**1 Products affected**

**3 Detailed description of change**

Product Change Notification					PCN MCS - Material change		
owner	creation date	release date	released by	change order no	rev	page	D10-062-773
ghezziisa	07.03.2022	10.03.2022	riedlan	2023640	B	1 of 2

Current product appearance	New product appearance
Tin (Sn)	Silver (Ag)

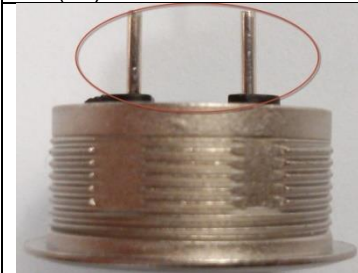
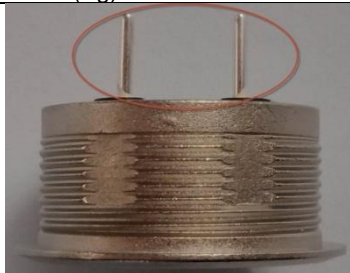
Plating material of the contact pins has been changed from tin to silver.

- Change of surface plating material on pins from tin to silver.
